City of Irvine
Parks Master Plan
FINAL | JULY 2015

ADA Assessment of Play Areas in Irvine Parks

TECHNICAL SUPPLEMENT

David Sills Park: Ages 2 to 5 Play Equipment Area

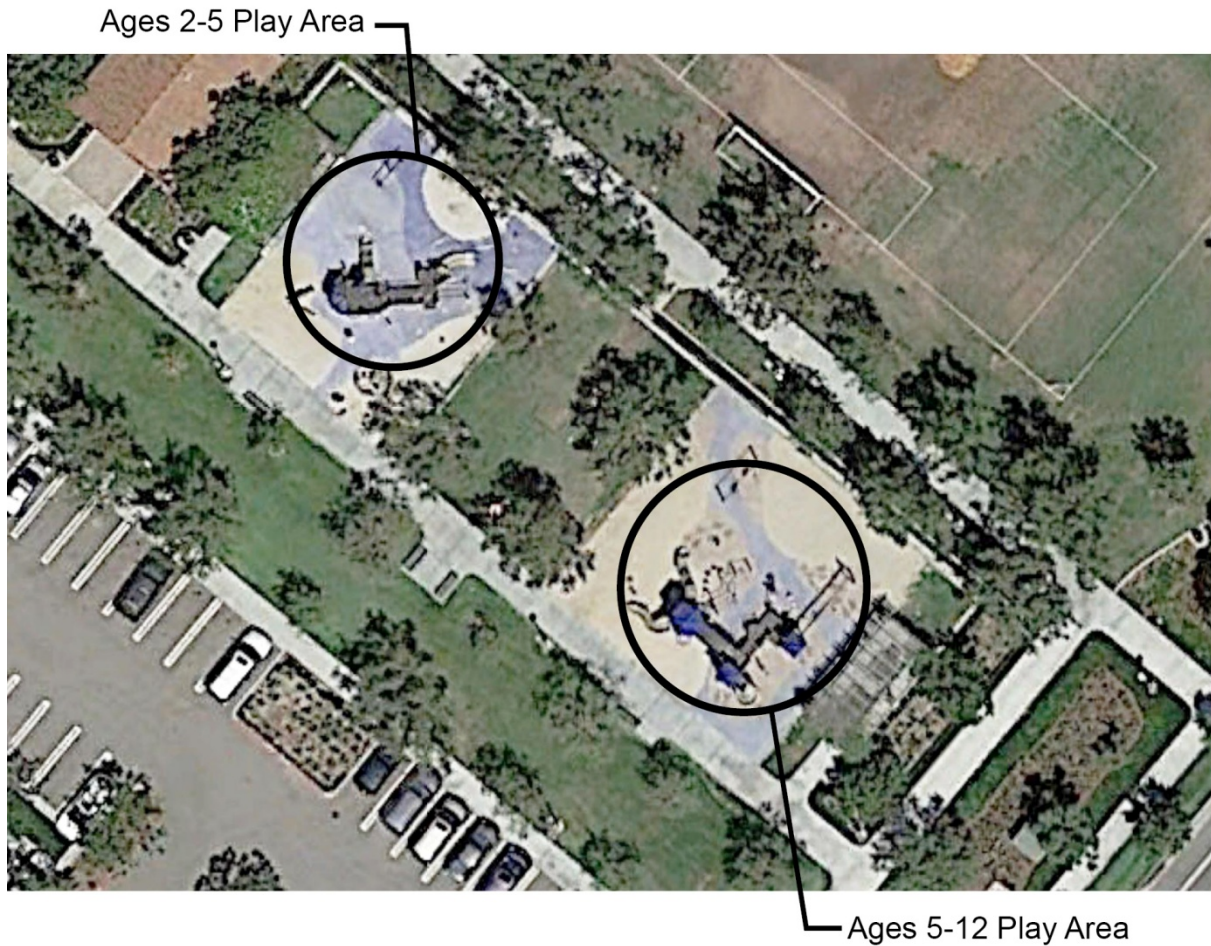
Action	Action Note	Planning Cost Estimate	Relevant Code
Improve or evaluate play area surface	Further evaluation of fall attenuation surface is recommended. Deteriorated top layer of poured in place surface has holes up to five by eight inches.	\$0	CBC 11B-1008.2.6.1 ADA 1008.2.6.1 ADA 1008.2.6.2
Install tread striping	Striping is not provided on stairs connecting play components.	\$200	CBC 11B-210.1 CBC 11B-504.4.1
Install or modify transfer system	The 30 by 48 inch ground space adjacent to transfer platform has a slope of up to 2.7 percent (2.0 percent maximum permitted).	\$400	CBC 11B-1008.3.1.3 ADA 1008.3.1.3
Provide an accessible path of travel	An accessible route is not provided to the turtle platform, route is four linear feet over sand surface.	\$120	CBC 11B-206.2.17.1 CBC 11B-1008.2 ADA 206.2.17.1 ADA 1008.2
Total		\$720

Dovecreek Park: Ages 2 to 5 Play Equipment Area

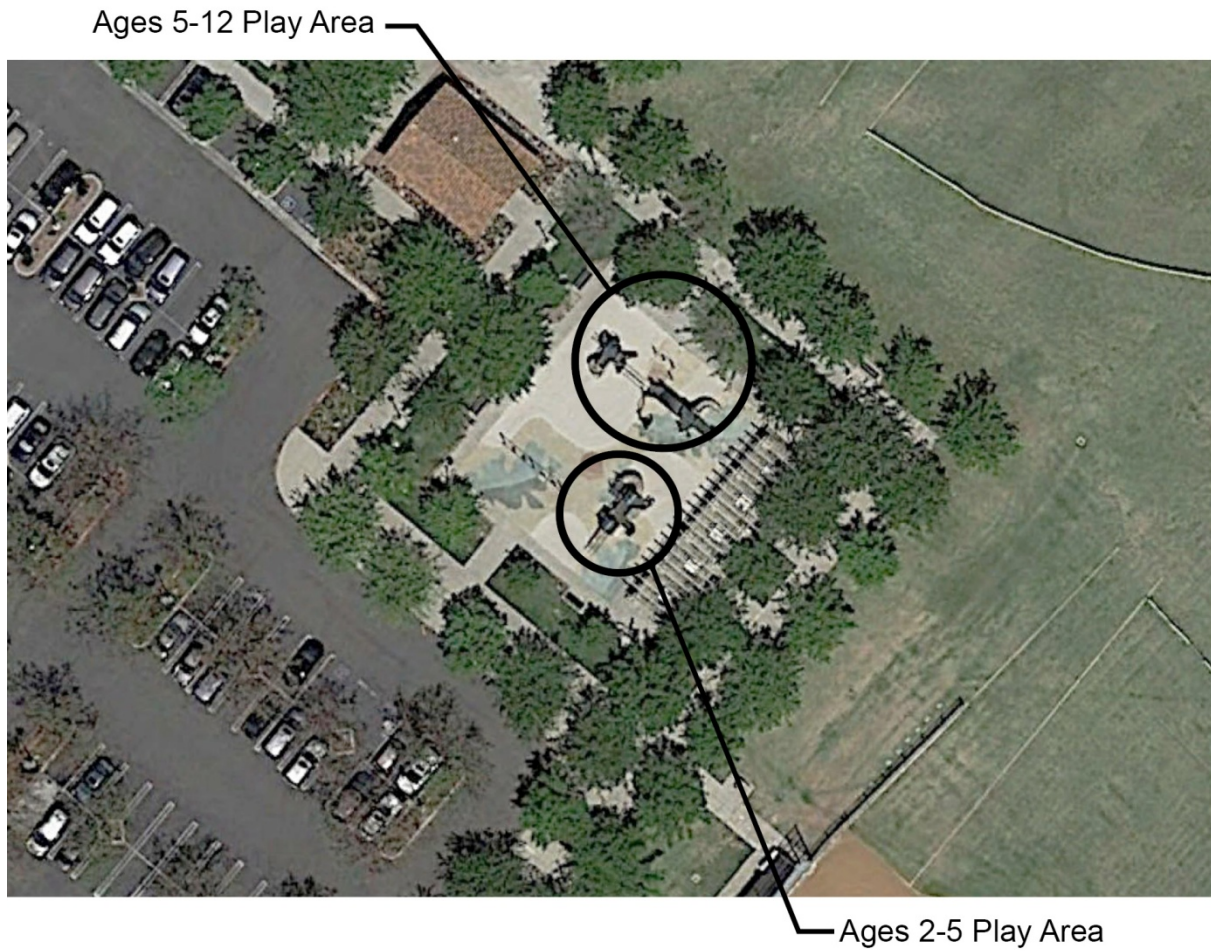
Action	Action Note	Planning Cost Estimate	Relevant Code
Install tread striping	Striping is not provided on stairs connecting play components.	\$200	CBC 11B-210.1 CBC 11B-504.4.1
Improve or evaluate play area surface	Further evaluation of fall attenuation surface is recommended. Top layer of poured in place surface worn and separating up to 1/2 inch at color seams.	\$0	CBC 11B-1008.2.6.1 ADA 1008.2.6.1 ADA 1008.2.6.2
Total		\$200

Heritage Park: Ages 2 to 5 Play Equipment Area

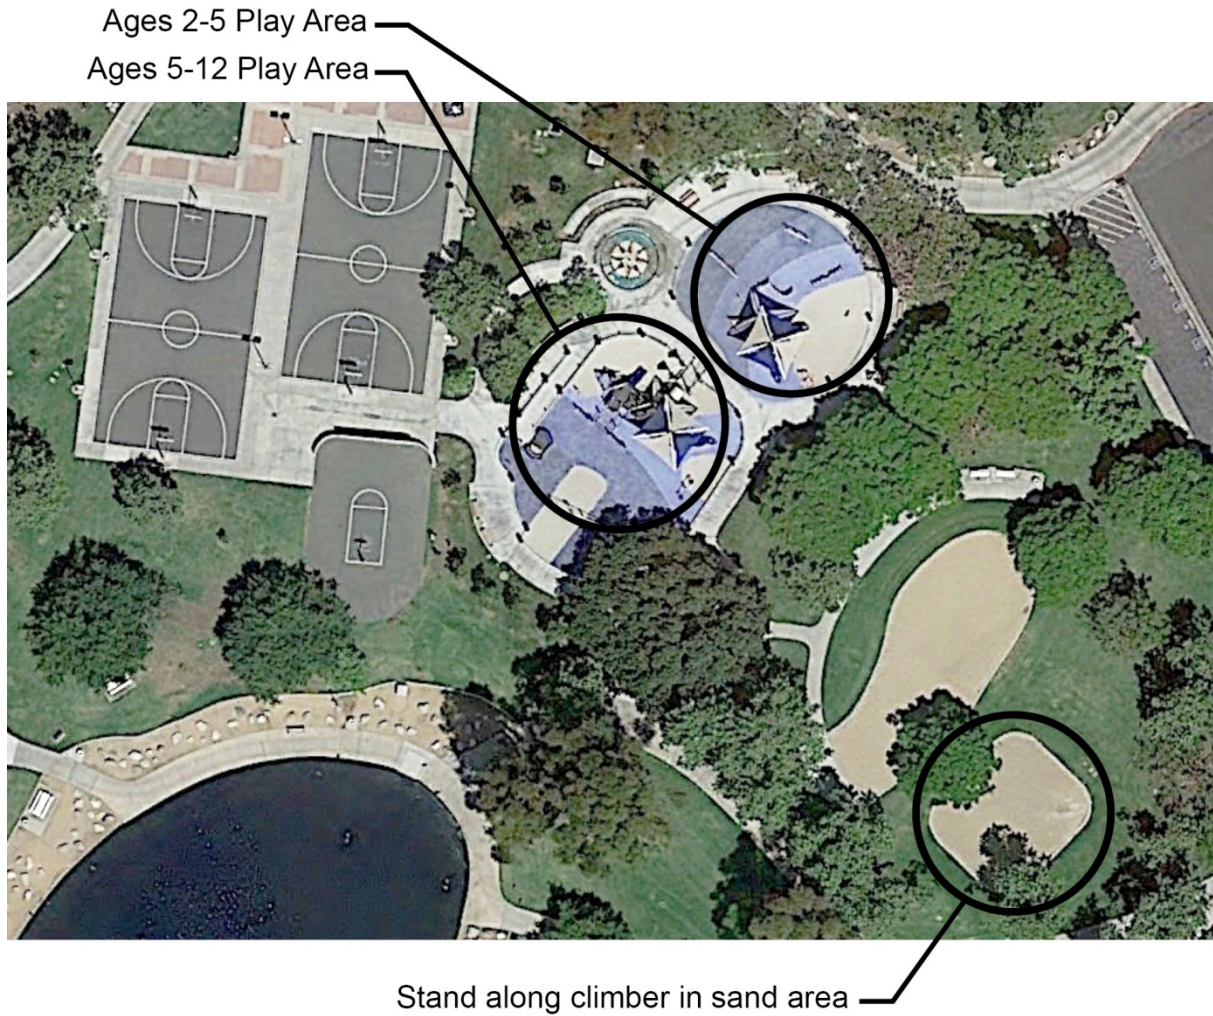
Action	Action Note	Planning Cost Estimate	Relevant Code
Provide an accessible path of travel	An accessible route is not provided to the only single user spring toy. Route is seven linear feet over sand surface.	\$210	CBC 11B-206.2.17.1 CBC 11B-1008.2 ADA 206.2.17.1 ADA 1008.2
Provide an accessible path of travel	Route into ground level boat structure is 32 inches wide (60 inches minimum is required. Route may be reduced to 36 inches wide for a maximum distance of 60 inches).	\$0	CBC 11B-1008.2.4.1 ADA 1008.2.4.1
Improve or evaluate play area surface	Further evaluation of fall attenuation surface is recommended. Deteriorated top layer of poured in place surface.	\$0	CBC 11B-1008.2.6.1 ADA 1008.2.6.1 ADA 1008.2.6.2
Install or modify transfer system	The 30 by 48 inch ground space is not centered at transfer platform due to curve in play surface.	\$400	CBC 11B-1008.3.1.3 ADA 1008.3.1.3
Provide an accessible path of travel	Elevated route on composite structure is 30 inches wide between central column and slide platform (36 inches minimum width is required; may be reduced to 32 inches minimum for a distance of 24 inches maximum).	\$5,000	CBC 11B-1008.2.4.2 ADA 1008.2.4.2

Ages 5-12 Play Area

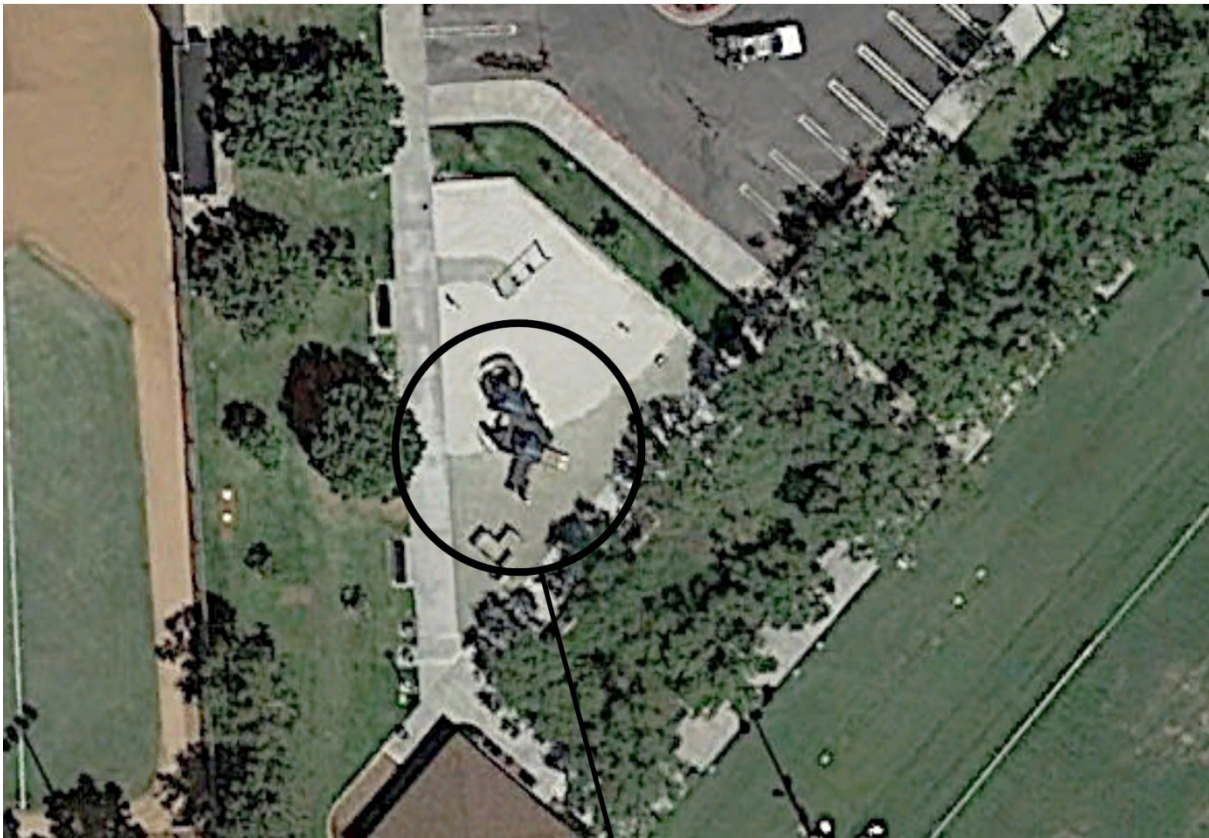
Action	Action Note	Planning Cost Estimate	Relevant Code
Provide an accessible path of travel	An accessible route is not provided to talk tube or dinosaur spring toy. Talk tube is located in sand 60 inches off accessible path of travel. Dinosaur spring toy is located on sand 96 inches off poured in place surface.	\$390	CBC 11B-206.2.17.1 CBC 11B-1008.2 ADA 206.2.17.1 ADA 1008.2
Improve or evaluate play area surface	Further evaluation of fall attenuation surface is recommended.	\$0	CBC 11B-1008.2.6.1 ADA 1008.2.6.1 ADA 1008.2.6.2
Install tread striping	Striping is not provided on stairs connecting play components.	\$200	CBC 11B-210.1 CBC 11B-504.4.1
Modify play component	A 60 inch diameter turning space is not provided at mirror in maze component. Path of travel inside maze is 40 inches wide and doglegs (44 inches wide minimum is required in play areas less than 1,000 square feet).	\$125	CBC 11B-1008.2.4.1 CBC 11B-1008.4.1 ADA 1008.2.4.1 ADA 1008.4.1

Ages 5-12 Play Area

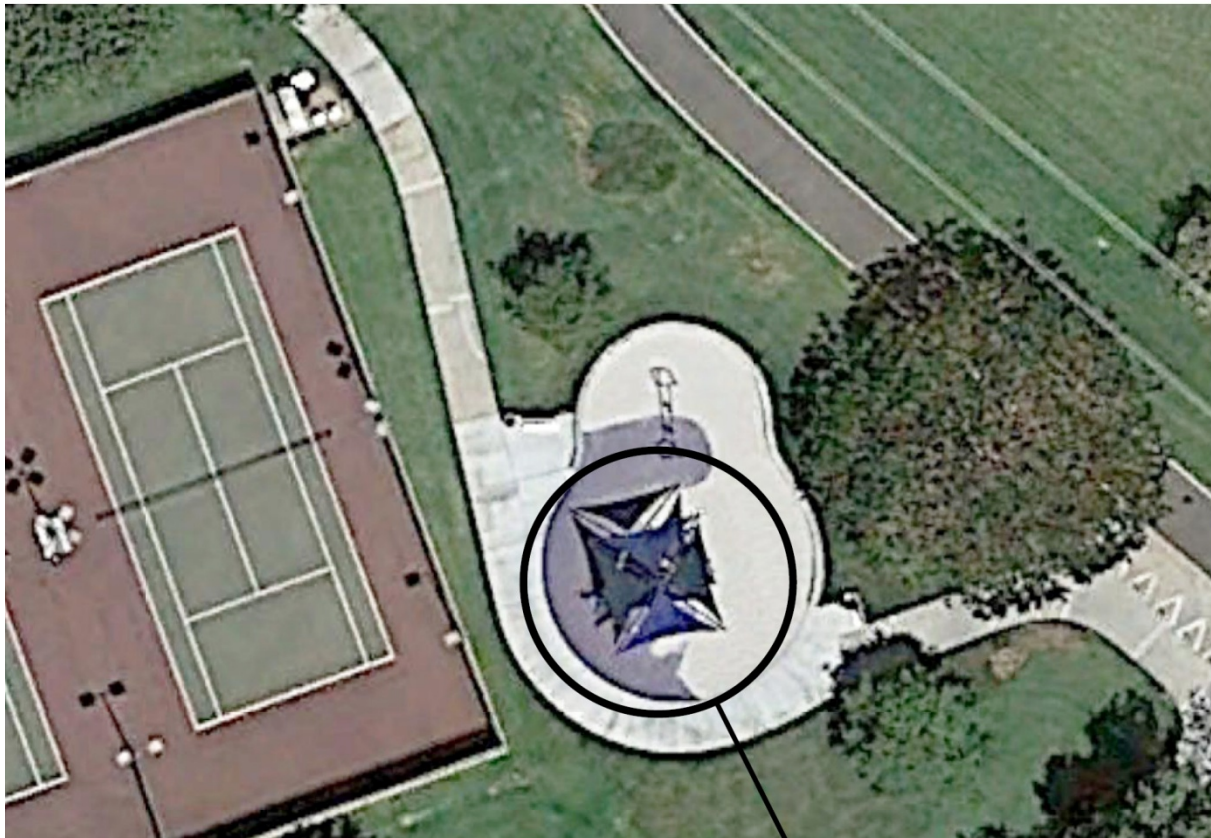
Action	Action Note	Planning Cost Estimate	Relevant Code
Provide an accessible path of travel	Route to play table is 29 inches wide (44 inches minimum required).	\$125	CBC 11B-1008.2 CBC 11B-1008.2.4.1 ADA 1008.2 ADA 1008.2.4.1
Improve or evaluate play area surface	Further evaluation of fall attenuation surface is recommended. Sand surface has migrated onto poured in place surface to a depth that would not be considered firm and stable. Ongoing maintenance required.	\$0	CBC 11B-1008.2.6.1 ADA 1008.2.6.1 ADA 1008.2.6.2
Install tread striping	Striping is not provided on stairs connecting play components.	\$200	CBC 11B-210.1 CBC 11B-504.4.1
Modify play component	A 30 by 48 inch minimum clear space is not provided at the play table due to slide.	\$400	CBC 11B-1008.4.1 CBC 11B-1008.4.2 ADA 1008.4.1 ADA 1008.4.2
Provide an accessible path of travel	Elevated route on composite structure is 17-1/4 inches wide for 50 inches (36 inches minimum width required; width may be reduced to 32 inches minimum for a distance of 24 inches maximum).	\$5,000	CBC 11B-1008.2.4.2 ADA 1008.2.4.2

Ages 5-12 Play Area

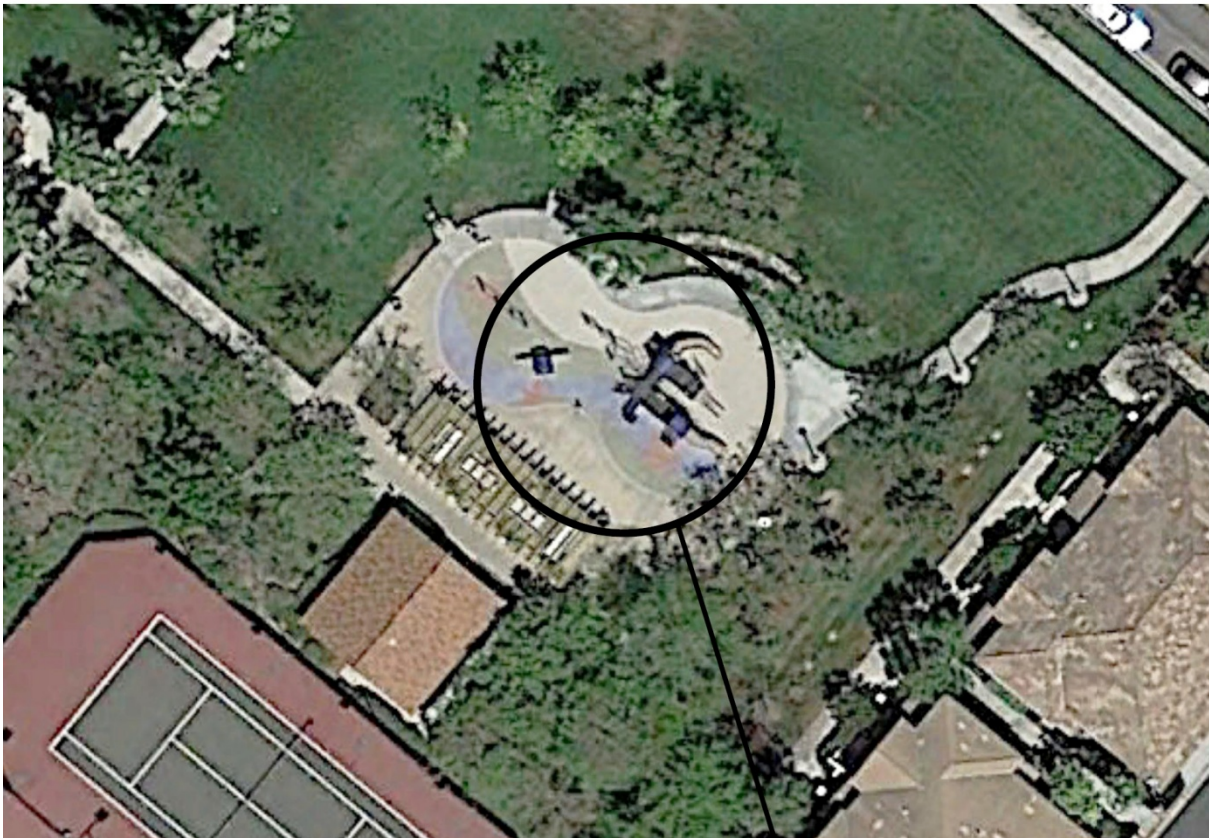
Action	Action Note	Planning Cost Estimate	Relevant Code
Provide an accessible path of travel	An accessible route is not provided to the stand alone climber. Climber is in sand. Route is 12 to 36 inches off poured in place surface.	\$120	CBC 11B-206.2.17.1 CBC 11B-1008.2 ADA 206.2.17.1 ADA 1008.2
Improve or evaluate play area surface	Further evaluation of fall attenuation surface is recommended.	\$0	CBC 11B-1008.2.6.1 ADA 1008.2.6.1 ADA 1008.2.6.2
Install tread striping	Striping is not provided on stairs connecting play components.	\$200	CBC 11B-210.1 CBC 11B-504.4.1
Modify play component	A 30 by 48 inch minimum clear space is not provided at stand alone climber due to sand surface.	\$400	CBC 11B-1008.4.2 ADA 1008.4.2
Total		\$720

Las Lomas Park: Ages 2 to 5 Play Equipment Area

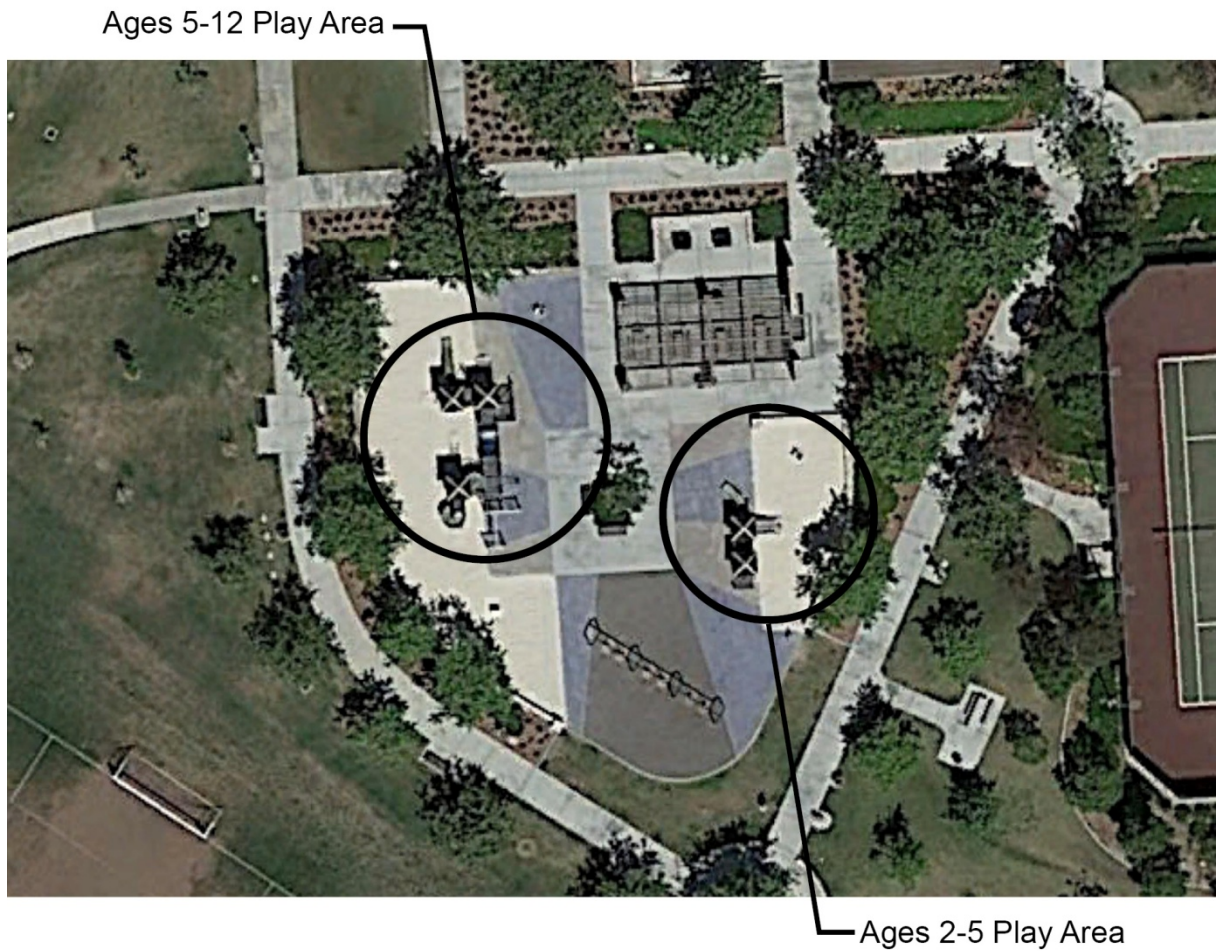
Action	Action Note	Planning Cost Estimate	Relevant Code
Provide an accessible path of travel	An accessible route to the spring toy is not provided. Route is 10 linear feet over sand.	\$300	CBC 11B-206.2.17.1 CBC 11B-1008.2 ADA 206.2.17.1 ADA 1008.2
Improve or evaluate play area surface	Further evaluation of fall attenuation surface is recommended. There is a 1/2 inch gap between poured in place surface and adjacent concrete for seven linear feet.	\$0	CBC 11B-1008.2.6.1 ADA 1008.2.6.1 ADA 1008.2.6.2
Provide an accessible path of travel	Route to play counter is 13 inches wide (44 inches minimum width required; route may be reduced to 36 inches for a maximum 60 inches).	\$500	CBC 11B-1008.2.4.1 ADA 1008.2.4.1
Install tread striping	Striping is not provided on stairs connecting play components.	\$200	CBC 11B-210.1 CBC 11B-504.4.1
Provide play components	Both parallel and front approach access to play table is blocked by fixed seating.	\$5,000	CBC 11B-1008.4.3 ADA 1008.4.3

Meadowood Park: Ages 2 to 5 Play Equipment Area

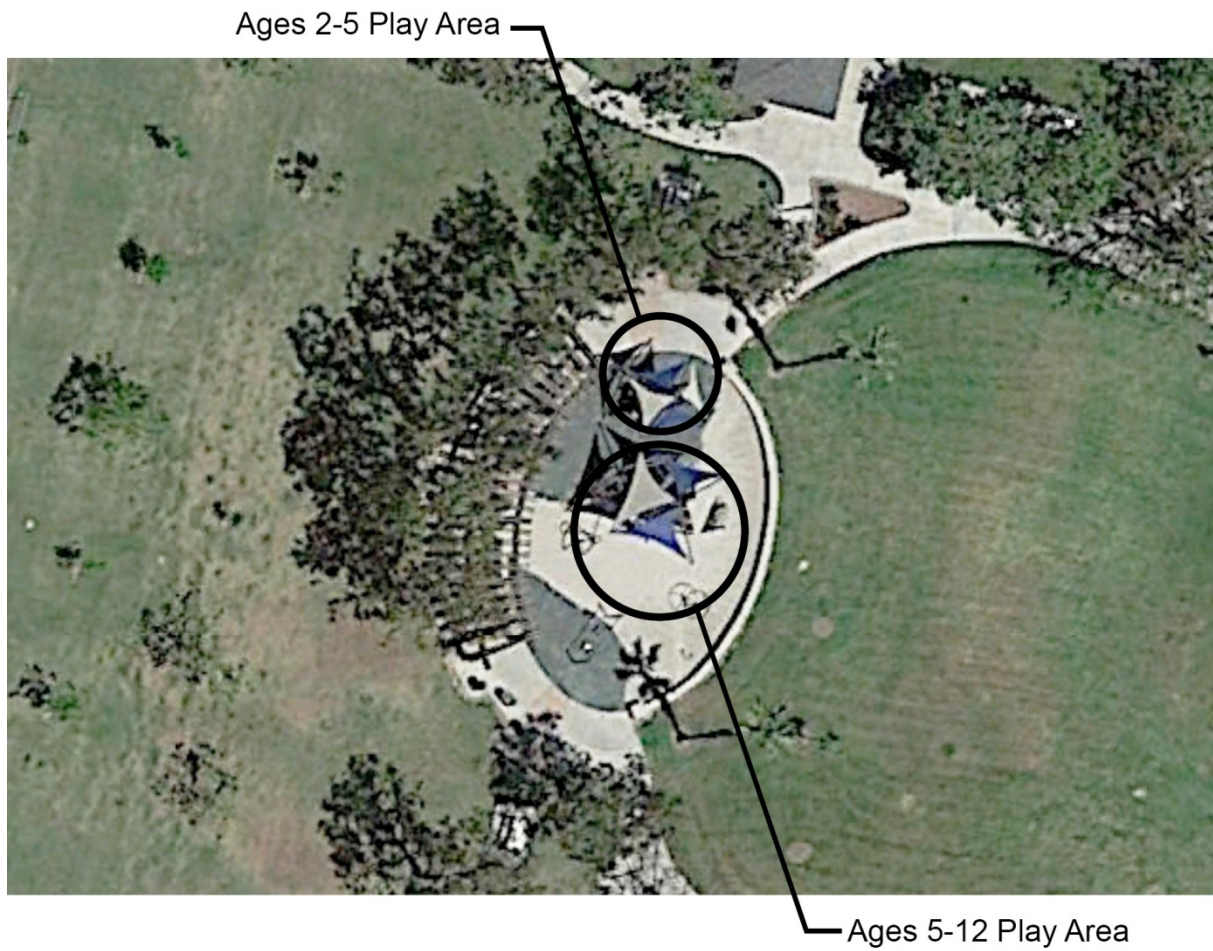
Action	Action Note	Planning Cost Estimate	Relevant Code
Improve or evaluate play area surface	Further evaluation of fall attenuation surface is recommended.	\$0	CBC 11B-1008.2.6.1 ADA 1008.2.6.1 ADA 1008.2.6.2
Install tread striping	Striping is not provided on stairs connecting play components.	\$200	CBC 11B-210.1 CBC 11B-504.4.1
Install or modify transfer system	The 30 by 48 inch ground space adjacent to transfer platform has a slope of up to 2.5 percent (2.0 percent maximum allowed).	\$400	CBC 11B-1008.3.1.3 ADA 1008.3.1.3
		\$600
